Heritage Aspects:

SMA's response:

Figure 1.0 (first floor rear bedroom)

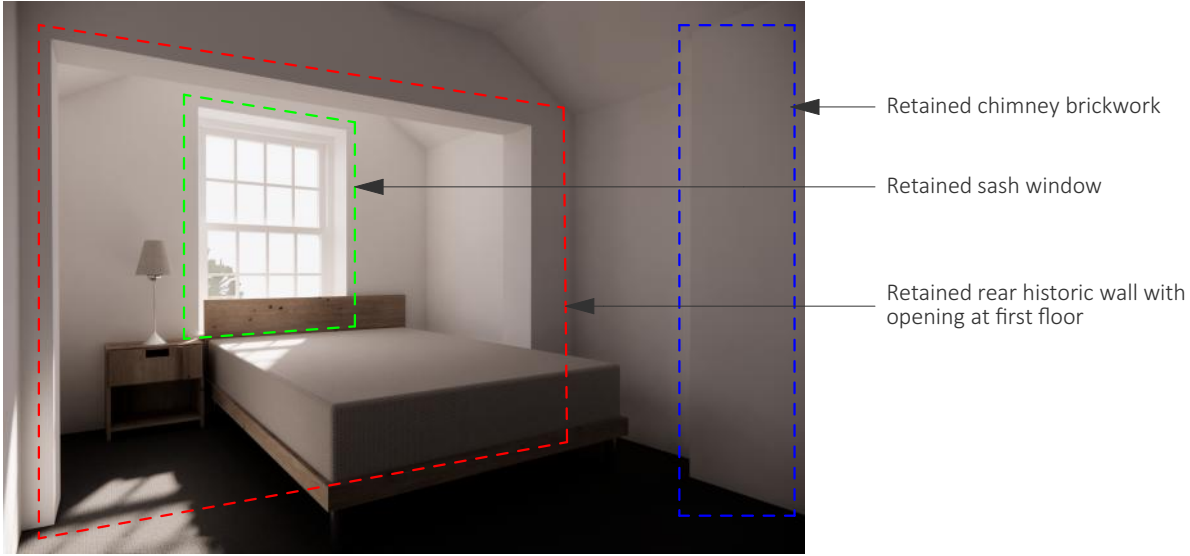
*“Demolish the existing gable end wall to allow the end of the range extended out further, a by approximately 1.53m in the same brickworks form albeit with a different fenestration detailing to the existing sash windows.”*

Instead of demolishing the gable end wall and extending out by 1.53m, we propose to extend the gable end using the same form, maintaining the historical wall as much as possible and making openings which clearly express the original structure into the design. The existing sash windows will be preserved and reinstalled, keeping the new extension in keeping with the original design. (See figure 1,2 and 3)

Figure 2.0 (ground floor rear gable end internal view)

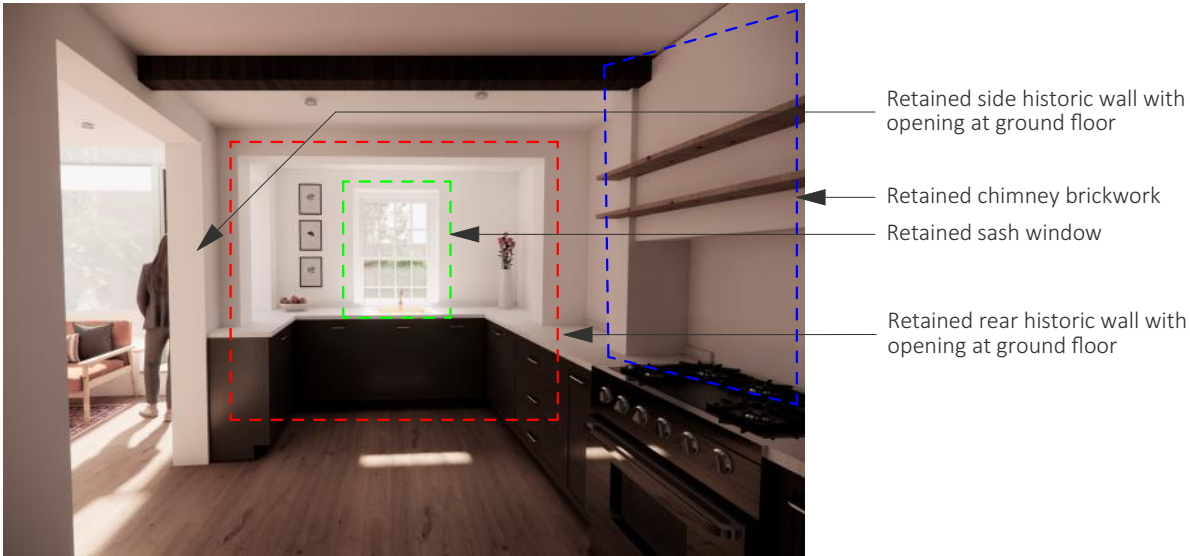
*“Removal of the first-floor fireplace and chimney breast brickwork, along with removal of the chimney brick brickwork below in the kitchen. Whilst it appears that the brick chimney stack of this rear range is to be retained.”*

*“Removal at ground floor level of the now internalised side wall of the rear range, in order to create an open kitchen/garden room area.”*

Rather than removing the chimney breast and stack at the rear range, we propose to retain the chimney breast on all levels. (See figure 2 and 3)

In response to the concern about removing the internal side wall of the rear range, we propose to reduce the size of the opening and retain more of the historic wall, ensuring a clearer preservation of the original elements while still creating the necessary space for the kitchen and garden room. (See figure 2 and 3)
